Application for Land Use Action

Master File #: MOD-2018-002

Please find the attached compilation of documents that represent the changes to the proposed design of the Milwaukie Ledding Library. The design team has conducted a series of precise modifications to the previously submitted design to better optimize the value of the project.

These changes are being submitted as a Type II – Minor Modification to the original Type III Approval. Below are our summary responses to the applicable approval criteria: MMC 19.9090.4.A

SHAPE THE NEW FOOTPRINT TO NAVIGATE NATURAL SITE FEATURES

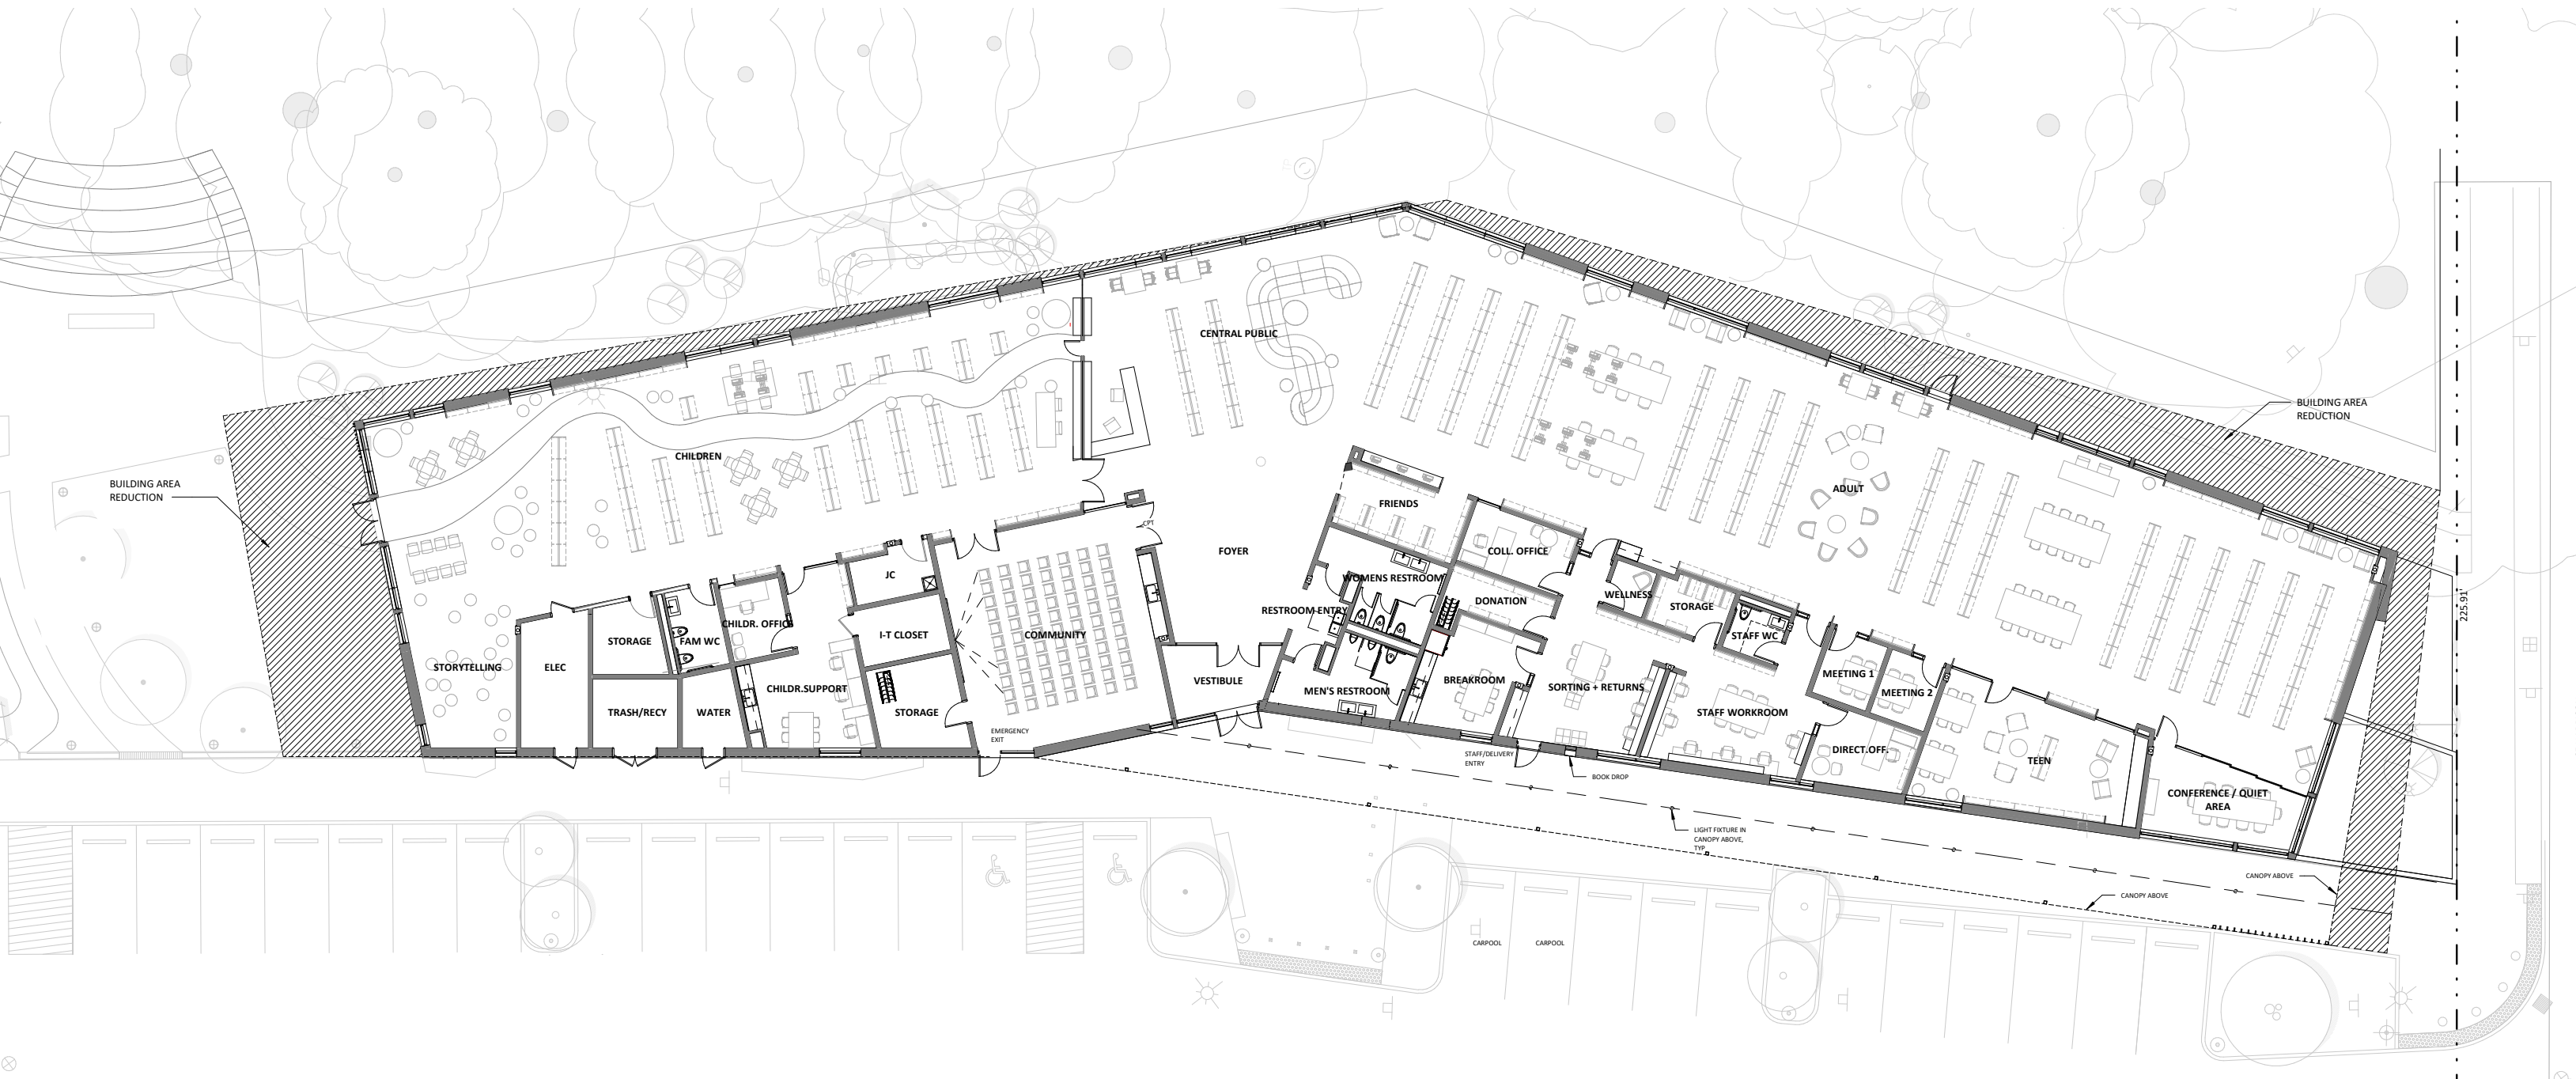
To summarize the design changes, the primary modification has been a building footprint reduction to the southeast corner and north end of the building. Other minor footprint adjustments have been made to other footprint edges to maintain original design concepts and to accommodate interior space reconfigurations.

Site Plan with WQR and HCA Disturbance
Milwaukie Ledding Library - Milwaukie, Oregon

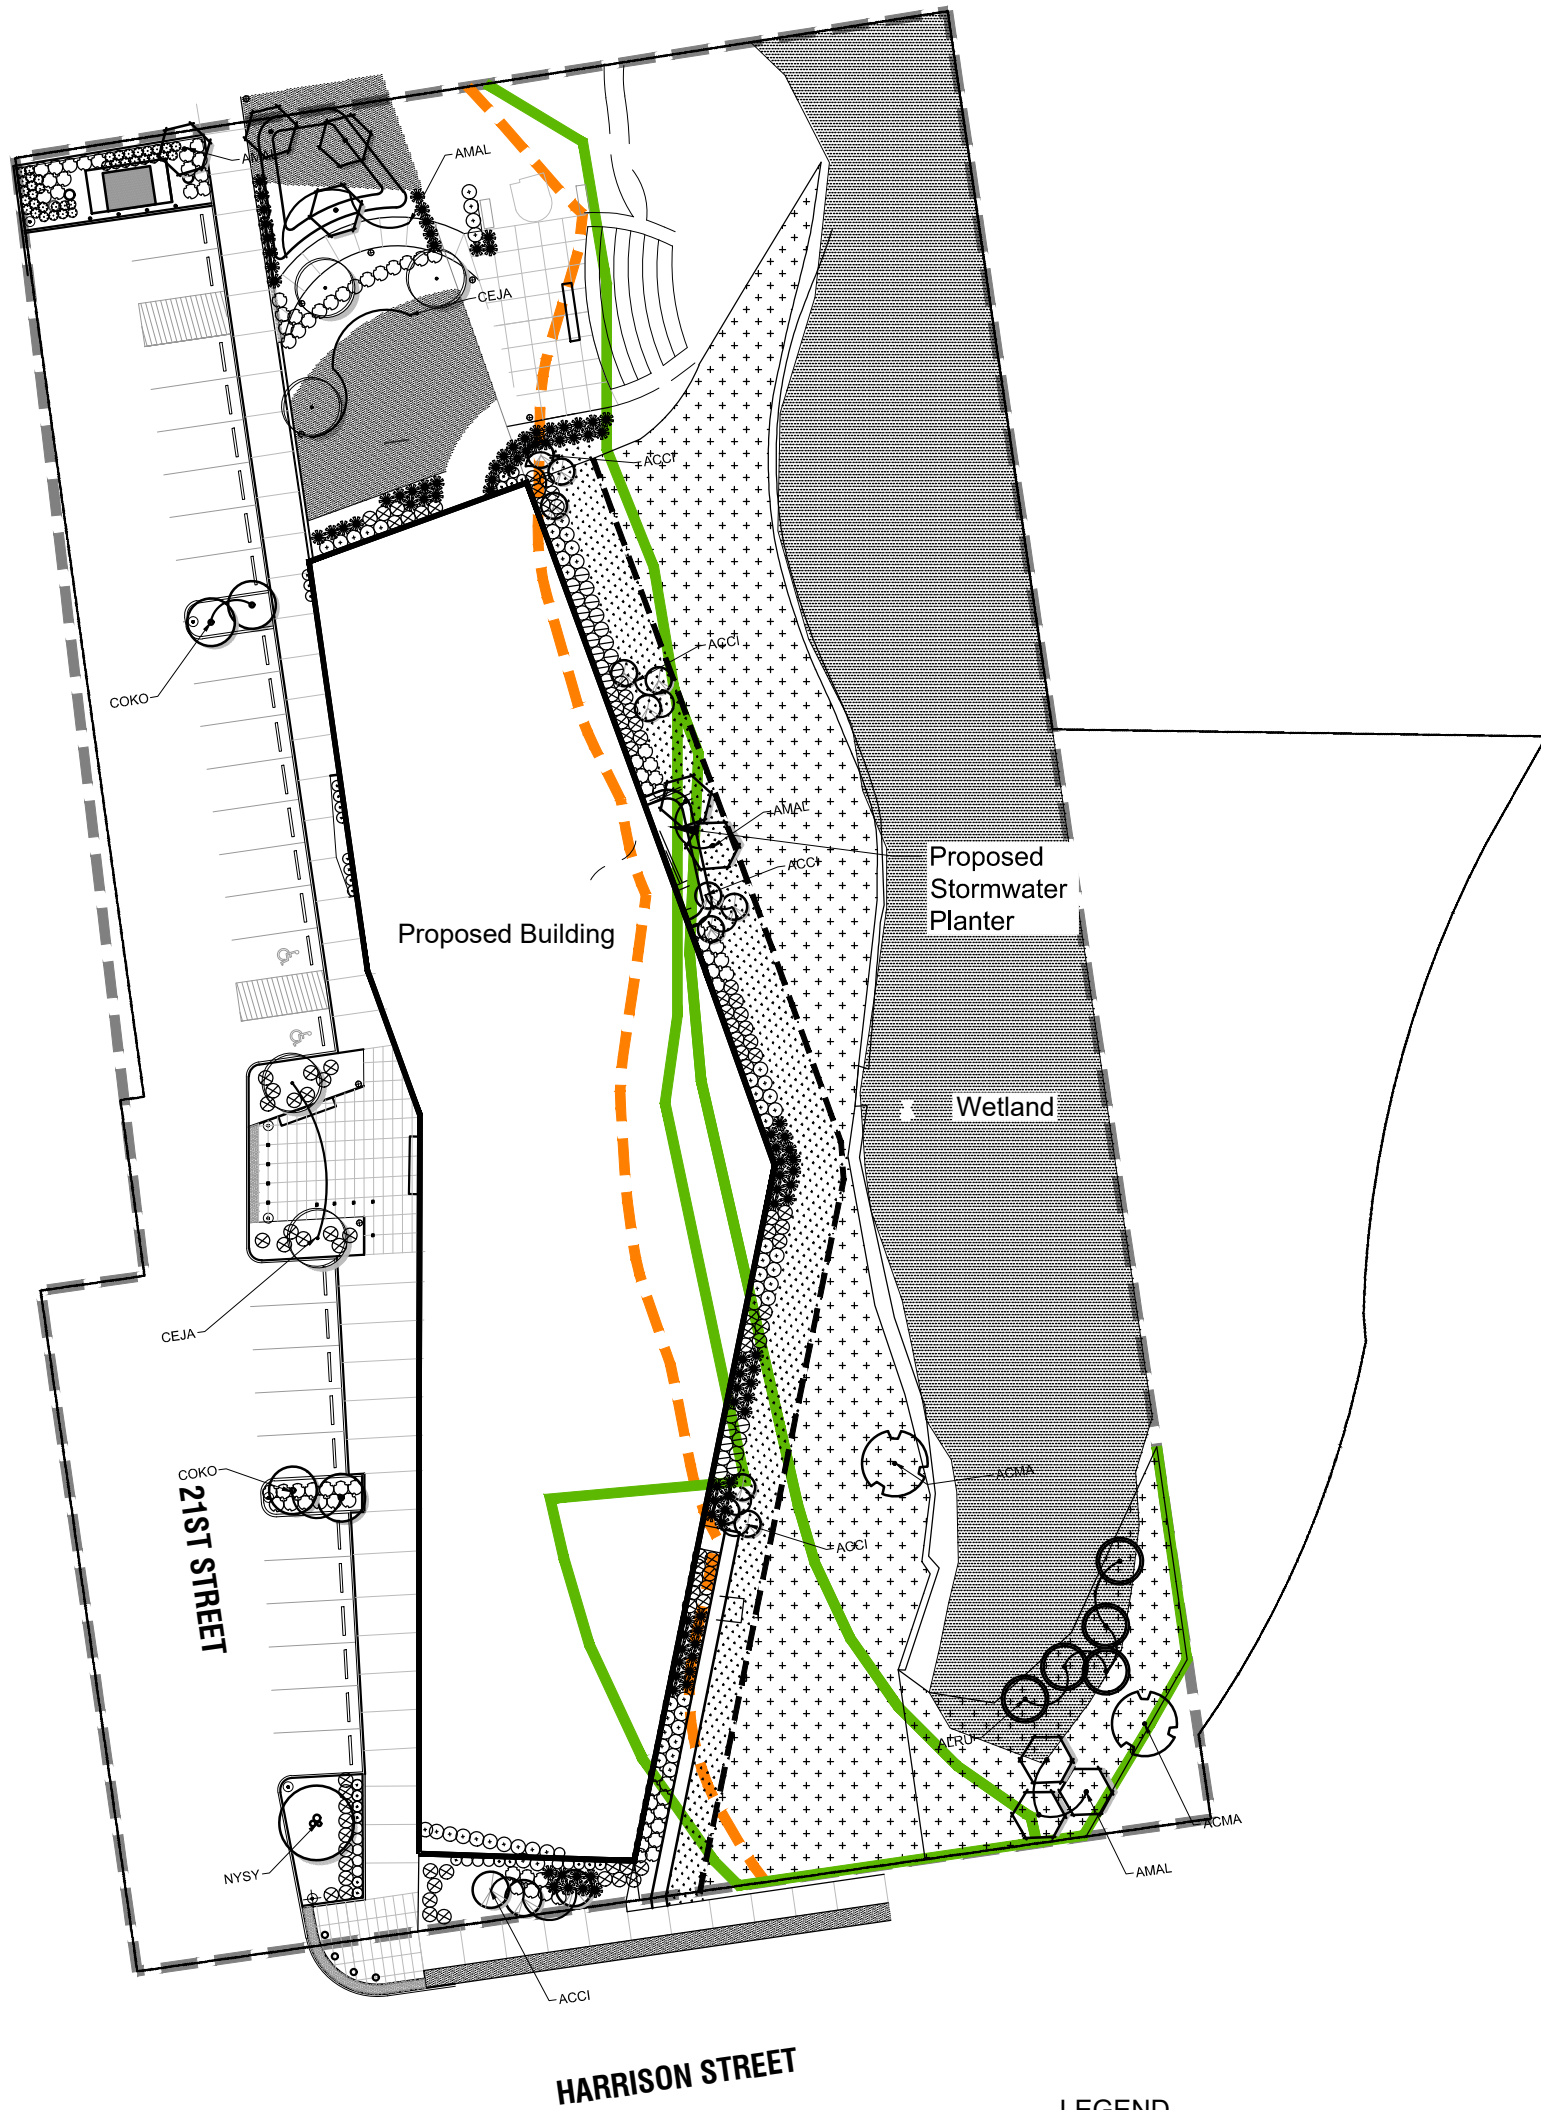
As noted above, changes in the building footprint occurred largely on the east side, resulting in reduced impacts to natural resources. Under the current design, the proposed library reconstruction would result in permanent impacts to 1,084 square feet (sf) of water quality resource (WQR) and 1,427 sf of habitat conservation area (HCA) and temporary impacts to 2,314 sf of WQR and 2,223 sf of HCA. Table 1 compares impacts to WQR and HCA under the original and revised site plans. Figure 4 (attached) shows the revised site plan as well as the resulting permanent and temporary impacts to the WQR and HCA.
